**TOWNSHIP OF GUELPH ERAMOSIA
 PLANNING REPORT # 1**

Application: Zoning By-law Amendment
File No.: ZBA 09/12
Date: January 29th, 2013

TO: Township of Guelph/Eramosa Council, Janice Sheppard (CAO) & Gaetanne Kruse (Planning Administrator)
FROM: Cuesta Planning Consultants Inc.
SUBJECT: Zoning By-law Amendment Application (ZBA 09/12)
 James Dick Construction Ltd. – Proposed Hidden Quarry

OPERATIONS PLAN

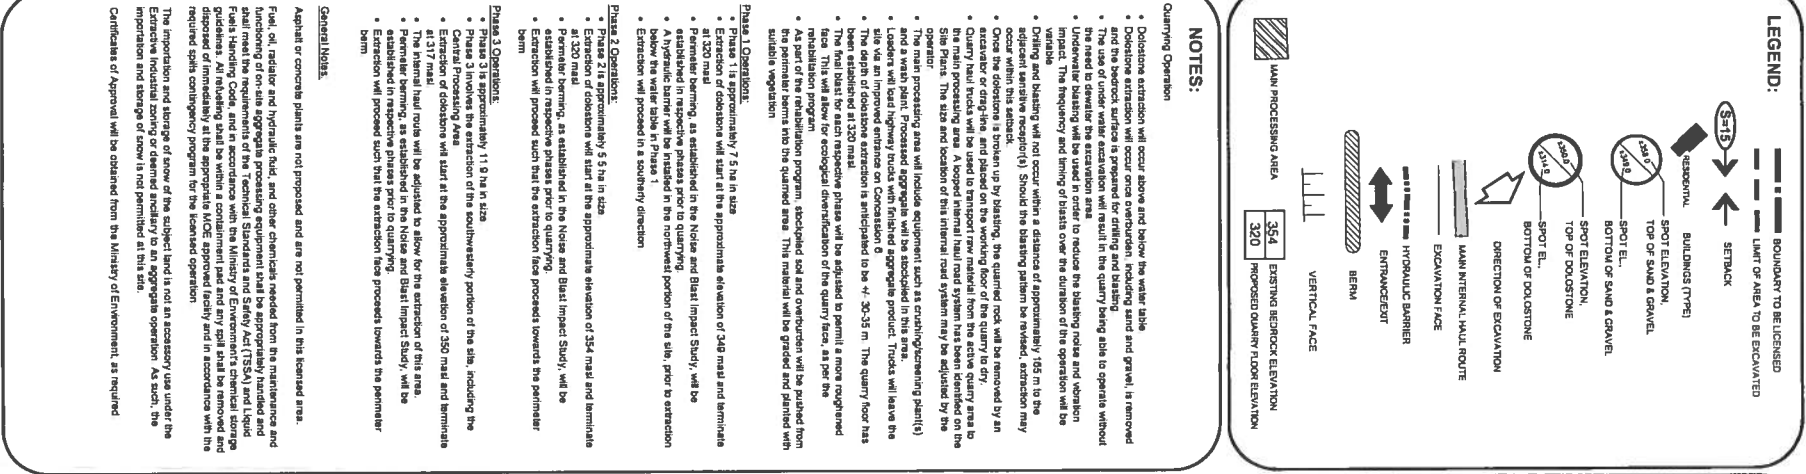
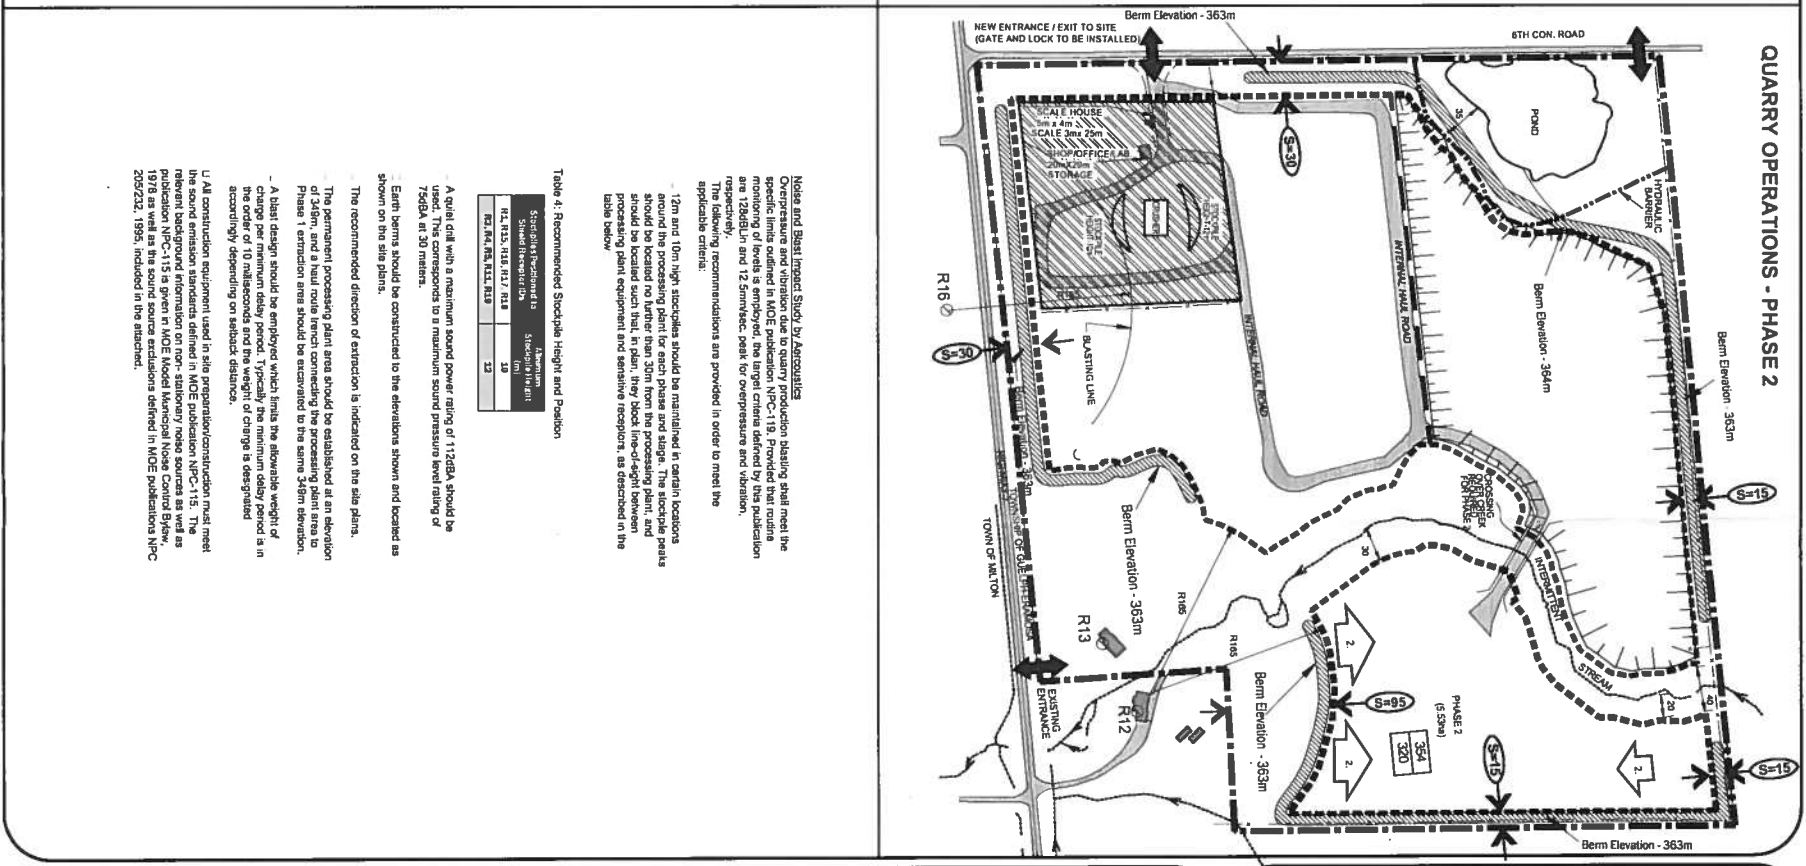
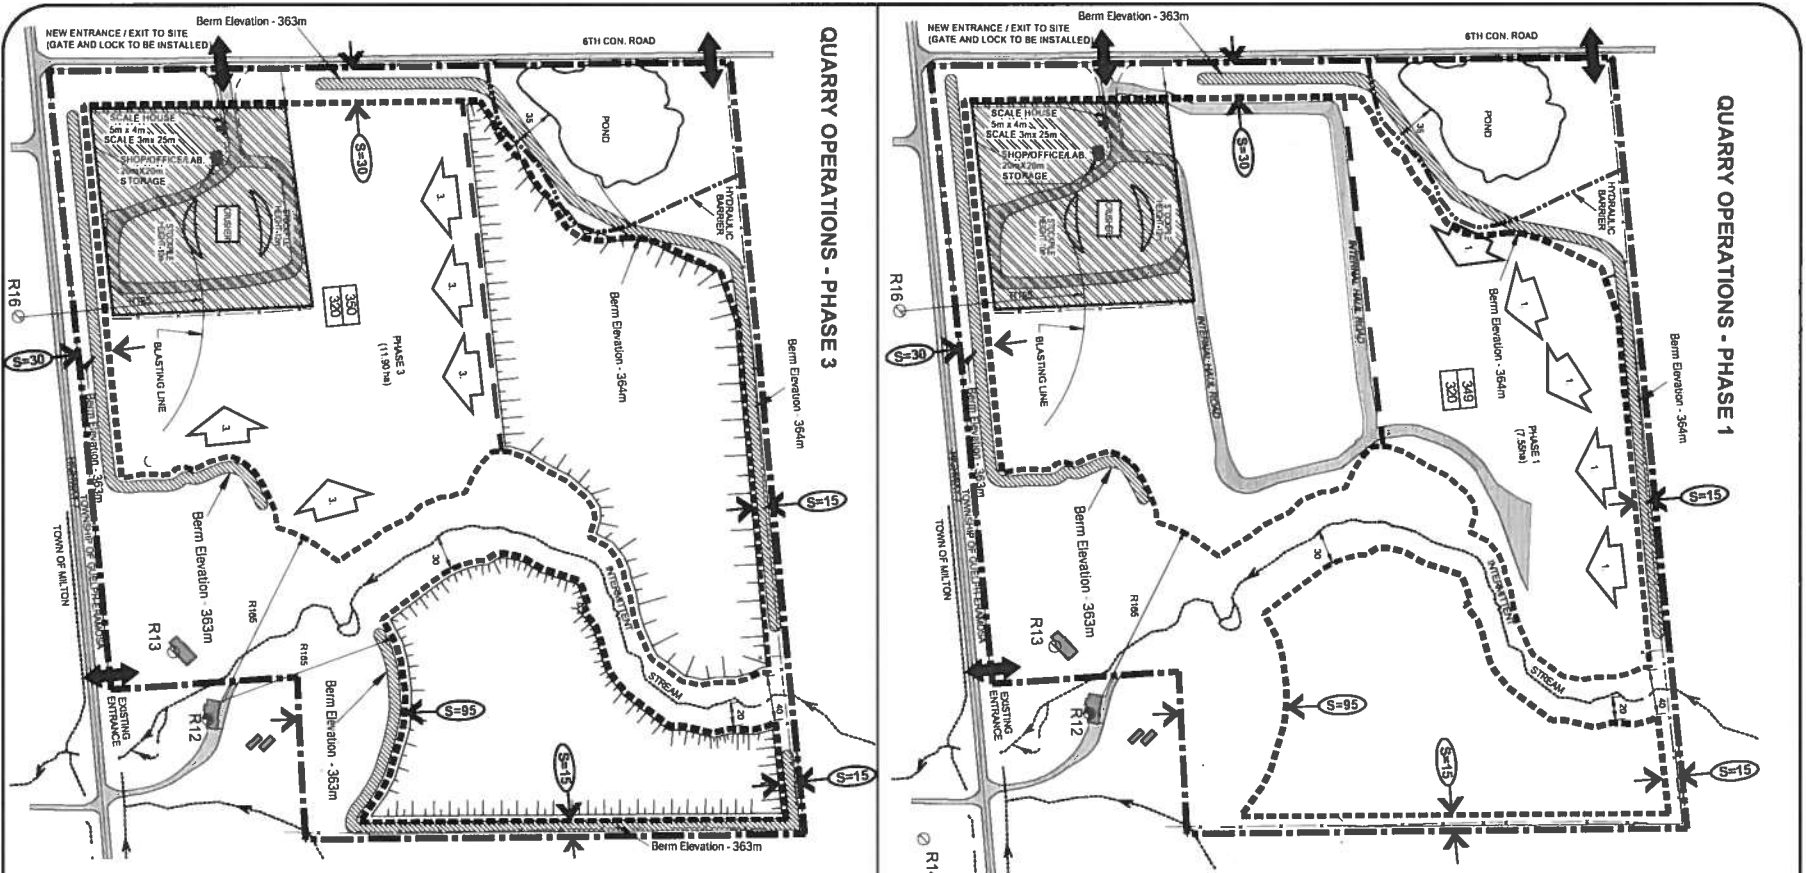
- The proposed entrance to be paved from the scale house to the public road.
- Will the existing service entrance shown on the Operations Plan remain or be removed?

- Fence/Gate geometry to be such that one full truck length can be off the travelled portion of the public road with the gate closed.
- Note 5 on the Operations Plan indicates that the existing property limits are fences although also indicates that fencing and repairs will be undertaken once extraction is initiated. An inspection of the existing fence condition is recommended to confirm the condition of existing fence and to establish the municipality's requirements in this regard.
